AERONAUTICAL CHARTING MEETING
Charting Group
Meeting – October 23 - 24, 2019

RECOMMENDATION DOCUMENT

FAA Control #19-02-342

Subject: Depiction of Profile Procedure Track for NPA Procedures

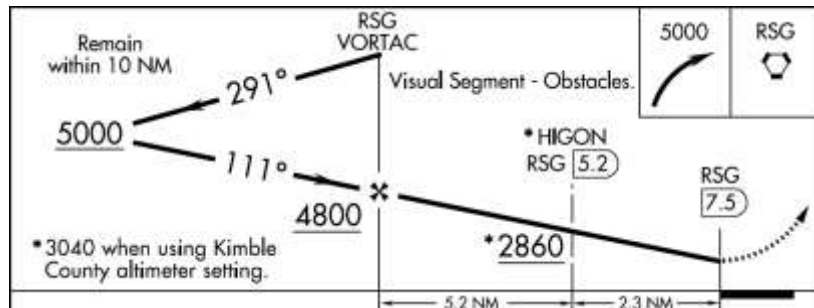
Background/Discussion: Current guidance in the IAC 4 Specification pre-dates a variety of rules and concepts that have been implemented in flight procedures in regards to Vertical Descent Angle (VDA) for Non-precision Approach (NPA) procedures. Paragraph 3.4.5.6 currently requires NPA procedures that are charted without vertically-guided minimums to depict a horizontal “level-off” for the vertical path from VDP or MDA, but **ONLY** when:

- VDP is published; or
- VDP is not published, but angle/TCH is provided
